Alameda Grant Line Solar 1

Final EIR

for Alameda County

Prepared by: PlaceWorks

Figure 3-4
Groundmount Array Layout

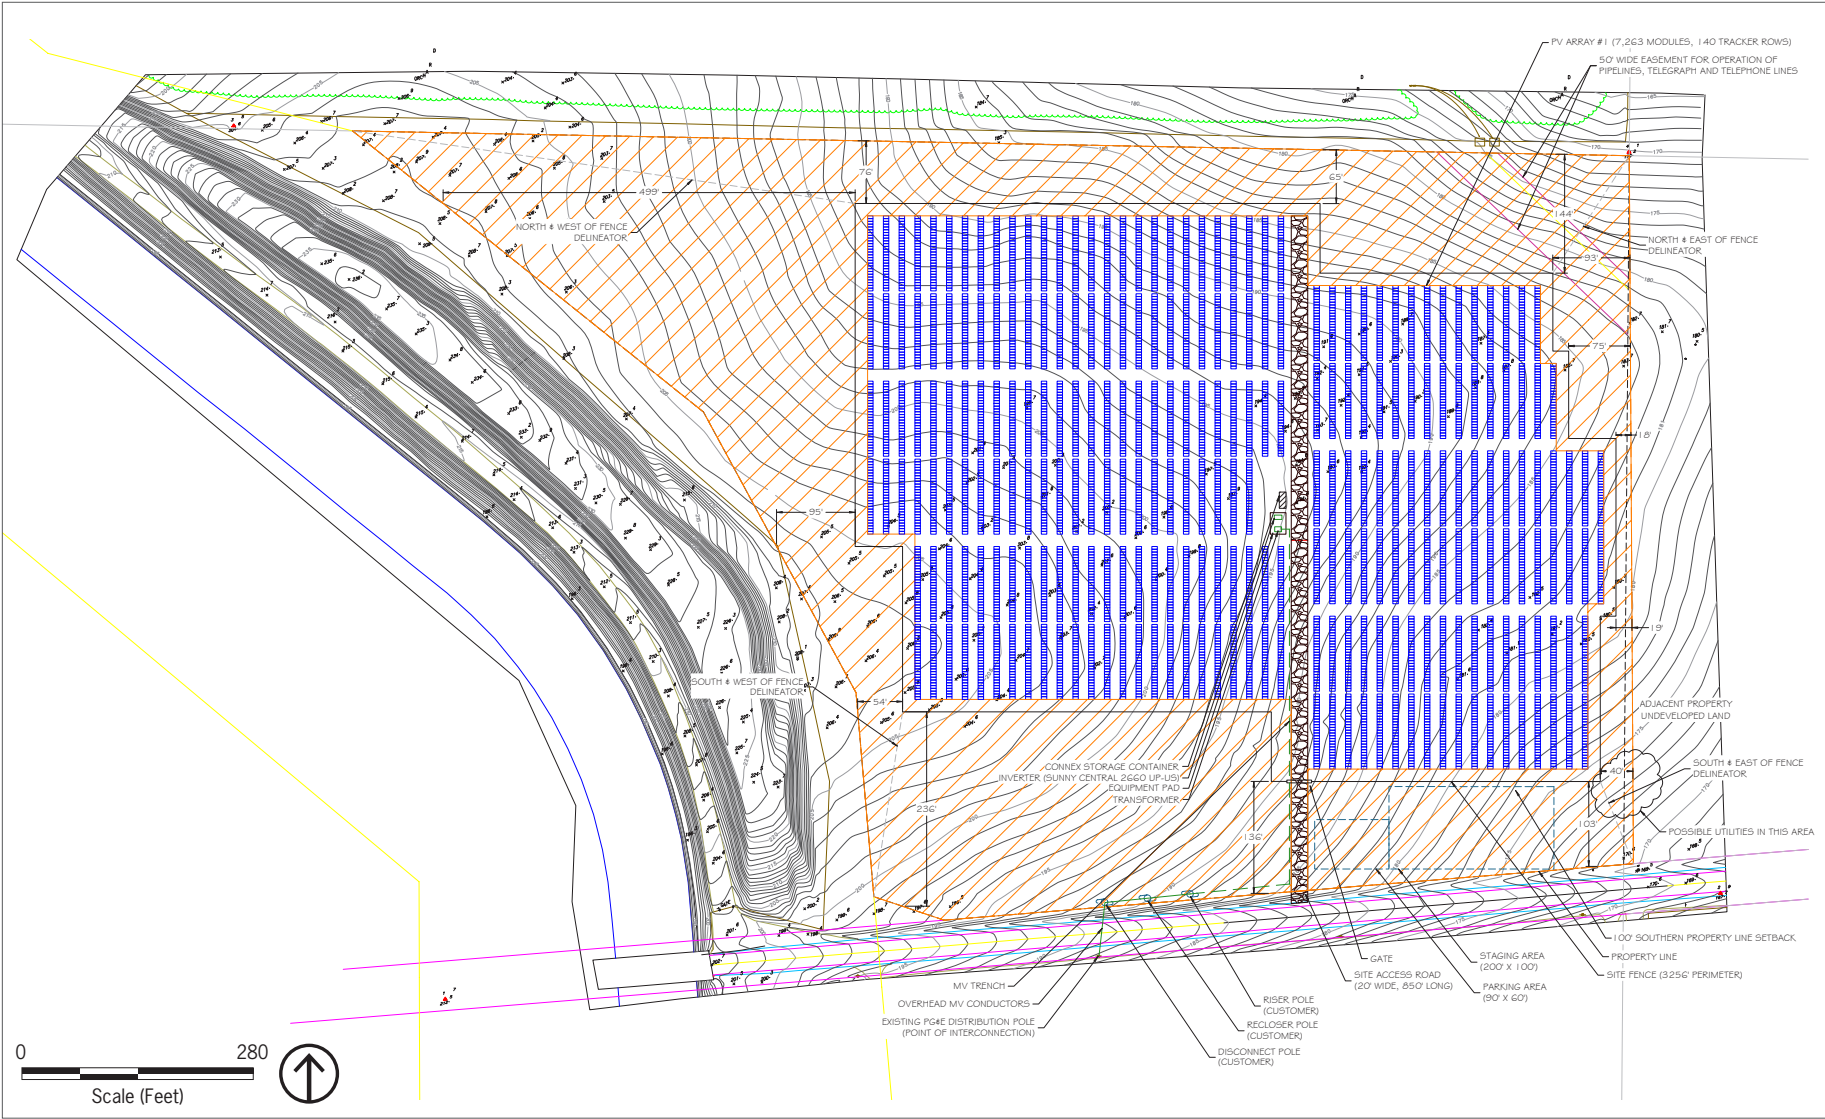
Figure 3-4, *Groundmount Array Layout*, is amended to show a revised site layout which shifts the solar arrays further east on the project site.
